SANDPOINT BEACH PARK MASTER PLAN REPORT

Job Number: 21-050
Date: November 2023

Sandpoint Beach Park Master Plan 2024 Amendment

Master Plan – 2024 Amendment

Site Concept Plan and Programming

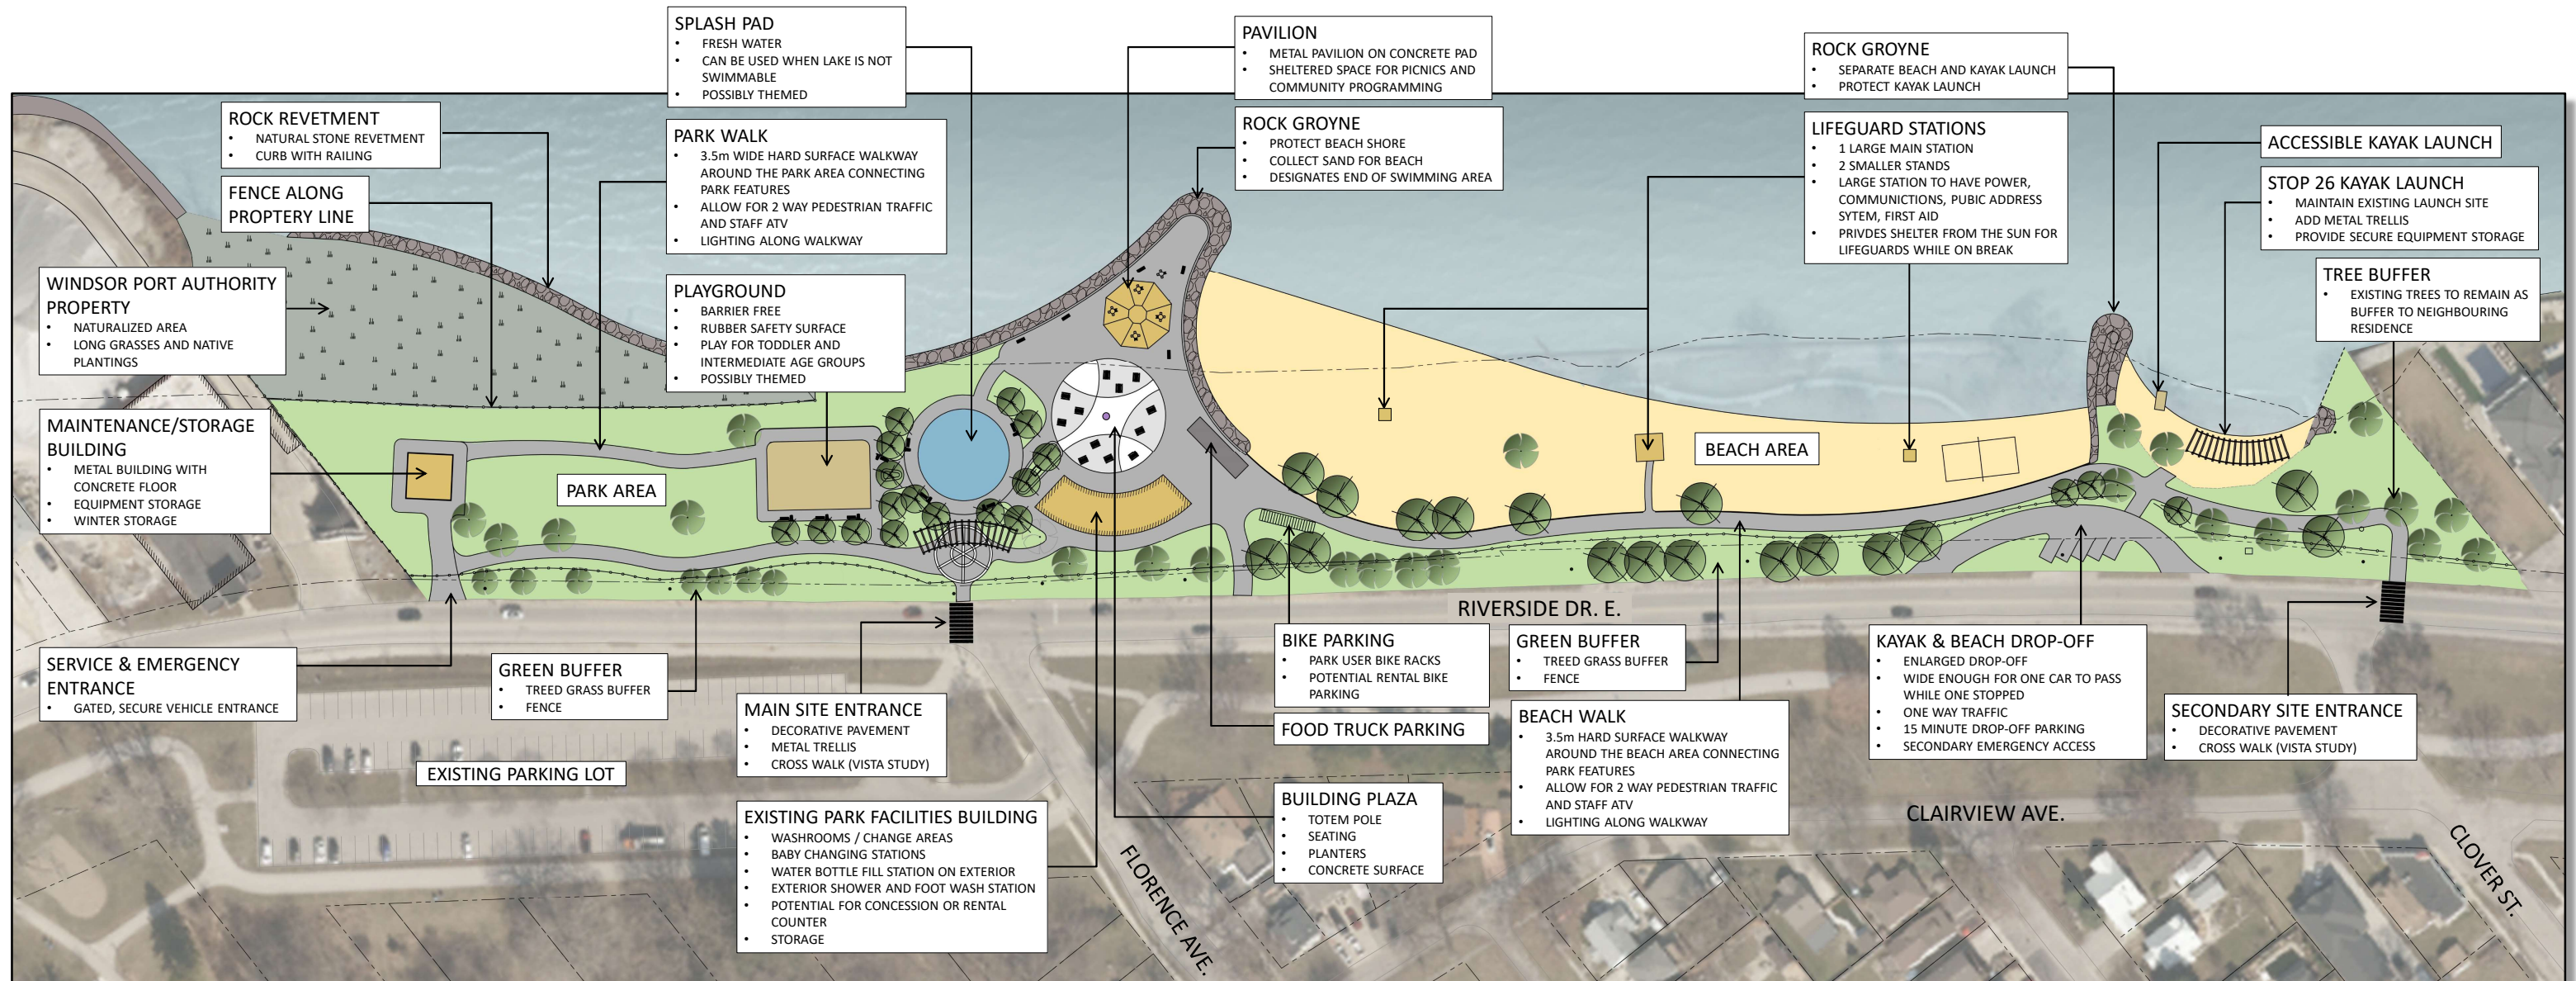
The main alteration to the 2023 Master Plan resulting from this amendment is the elimination of the Fishing Pier option at the west end of the site. The updated Master Plan will no longer provide access to the Windsor Port Authority property, which will be separated by a fence along the property line, making access to a fishing pier unfeasible. All other components identified in the functional program have remained as part of the updated Maser Plan, but their specific arrangement has been slightly shifted to accommodate the new land boundary considerations.

The Sandpoint Beach Park Master Plan image has been updated and is included as part of this amendment to the original 2023 report.

Title	SANDPOINT BEACH PARK MASTER PLAN		Date	JUNE 2022	FIGURE 9
	Project	SANDPOINT BEACH PARK MASTER PLAN		Scale	
		Project No.	21-050

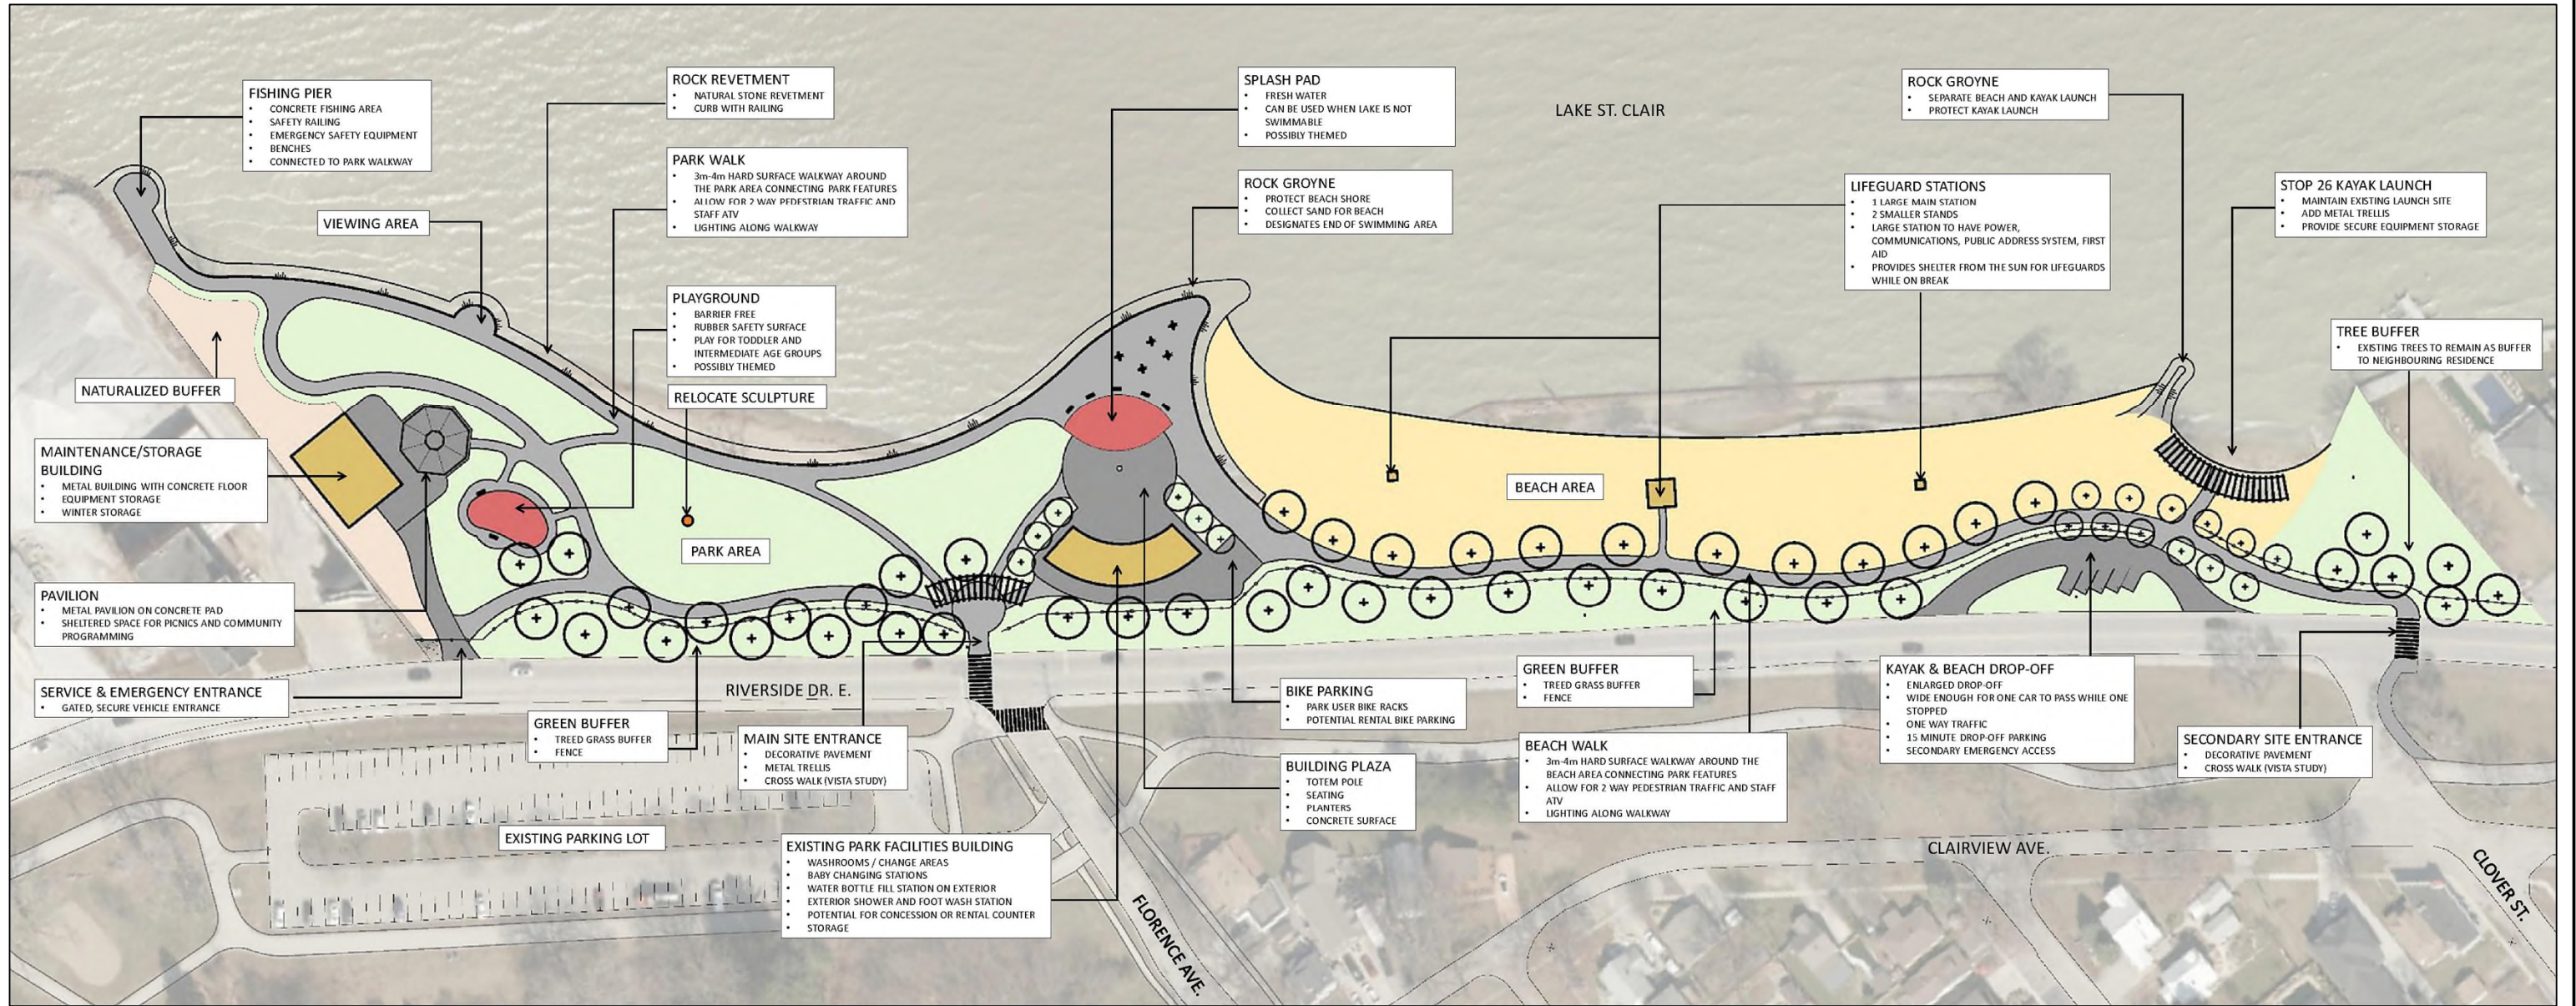
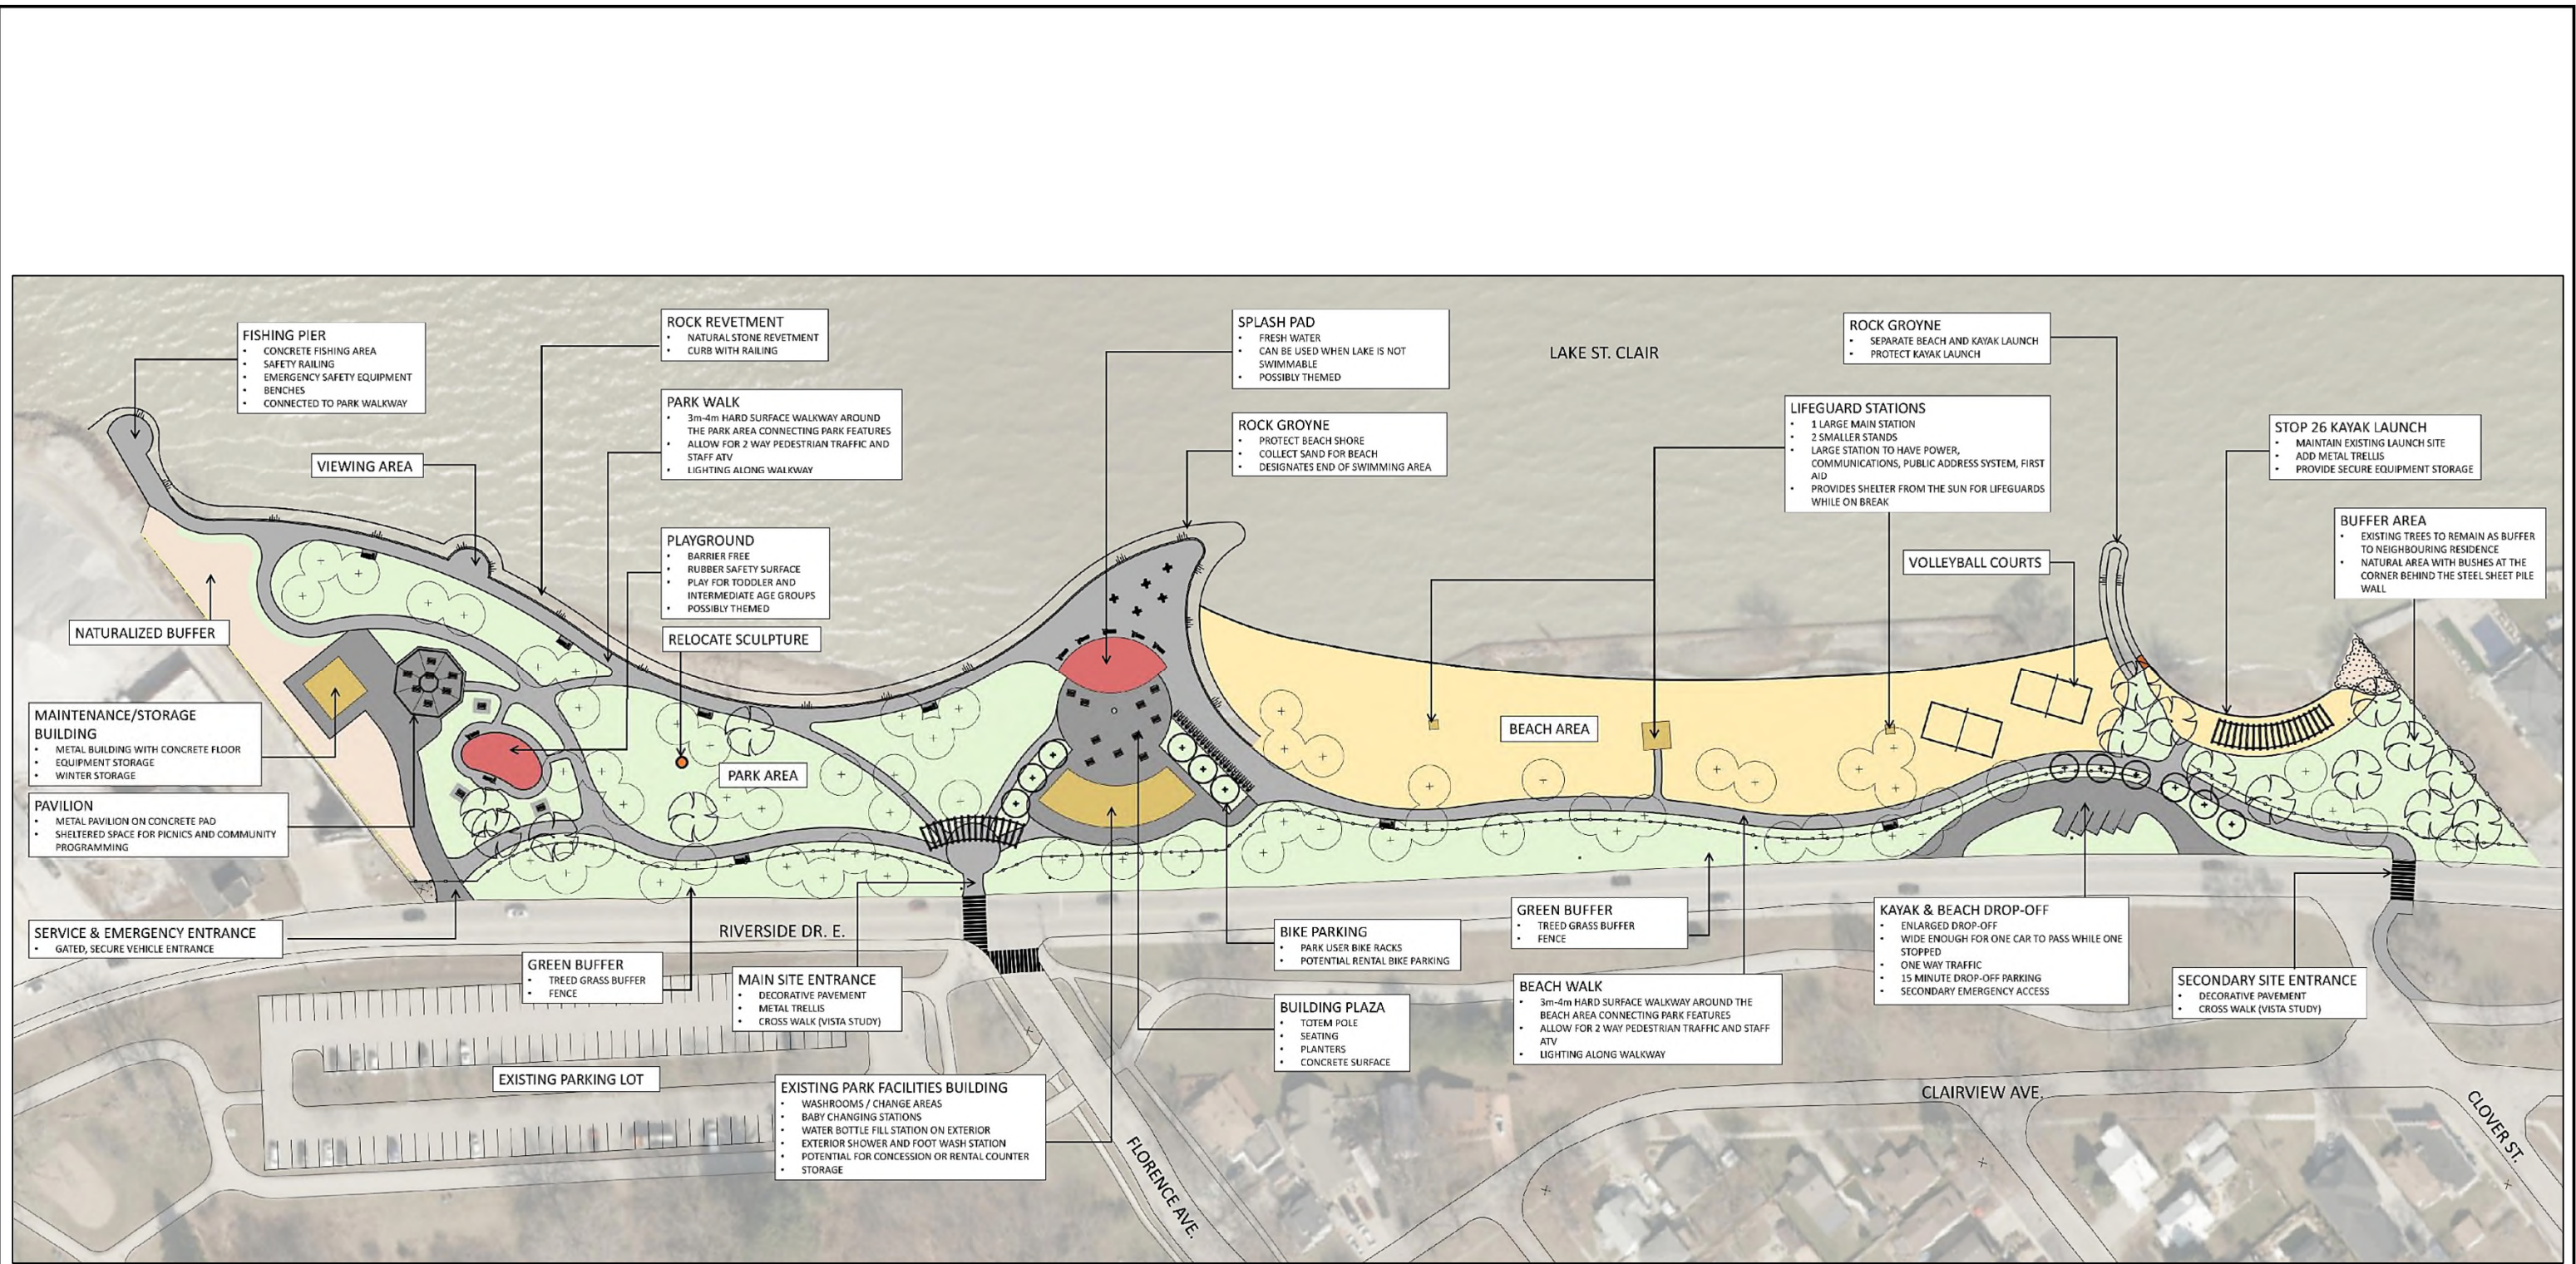
After careful consideration of the feedback received through the various sources outlined above, the Project Team revised and finalized the new Sandpoint Beach Park Master Plan, which is attached here as Figure 9. As illustrated, the final plan includes the following amendments:

- A designated bicycle parking area has been established next to the Main Facilities Building;
- More park benches and picnic tables have been added to the overall plan;
- Beach volleyball courts have been added to the new beach area;
- The rock groyne and trellis structure defining the kayak launch area at Stop 26 beach have been realigned to discourage intrusions into the neighbouring property to the east; and,
- The proposed tree plantings on the site as a whole have been adjusted to more accurately reflect the landscaping recommendations and help preserve views of the lake.

This plan has been updated to reflect the comments received from the draft plan.
